PRODUCT CHANGE NOTIFICATION

Bourns® Model SM453229 and SM453230 Series Chip LAN Transformers *Design and Manufacturing Process Change*

Terminal Dimensions of Current Transformer (Top view):

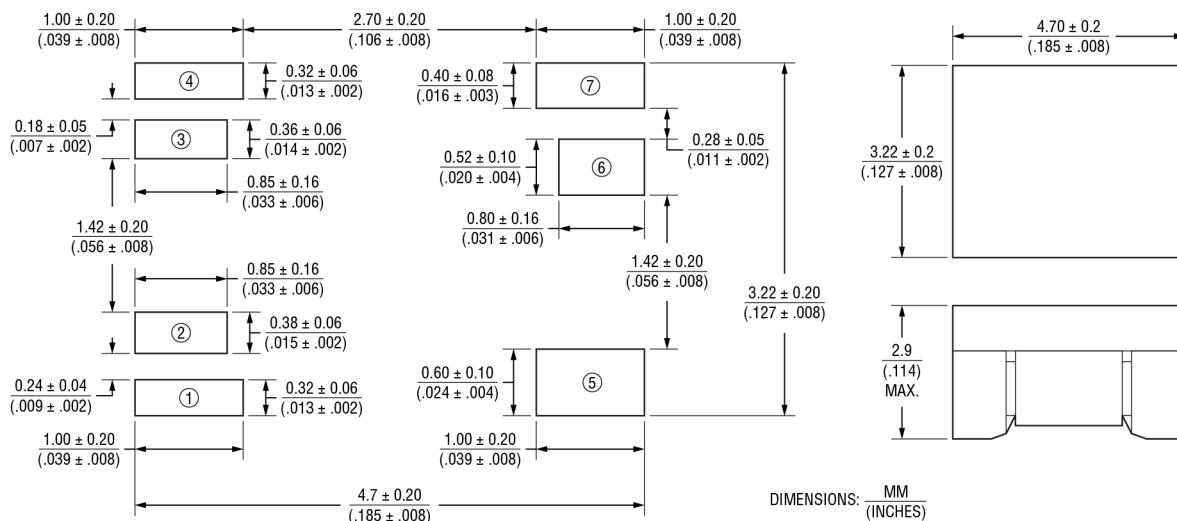
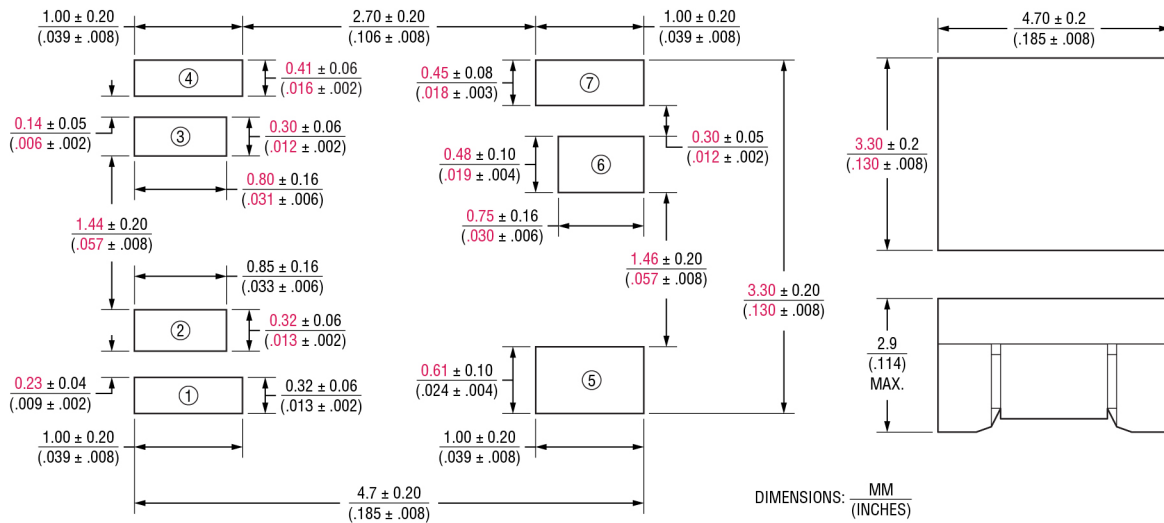
Riverside, California – August 26, 2021 – Effective November 18, 2021, Bourns is changing the core design and manufacturing process for the [Model SM453229 and SM453230 Series Chip LAN Transformers](#) to improve transformer performance and production efficiency. The modified core will include wire grooves on four of the seven terminal pads that can guide the wire leads to the proper position. The core size will be changed slightly.

The recommended layout remains unchanged. The modified transformer can be applied to the existing pad layout.

Terminal Dimensions of Revised Transformer (red) (Top view):

Bottom View of Current Transformer
Wire lead 1 and 2 entry to terminal pad at end-section

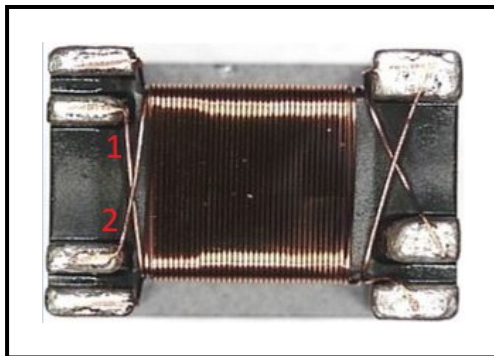
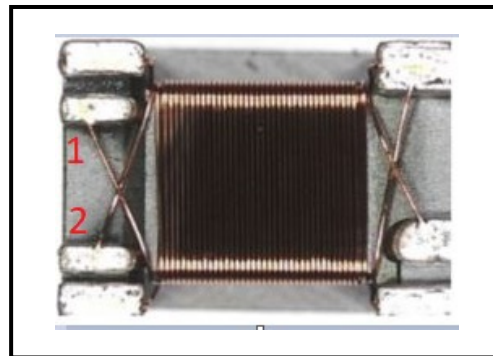
In addition, the manufacturing process will be changed to use winding machines with more spindles to increase the production rate. The transformer winding pattern will be modified as a result of this process change.

Bottom View of Revised Transformer
Wire lead 1 and 2 entry to terminal pad at approximate mid-section
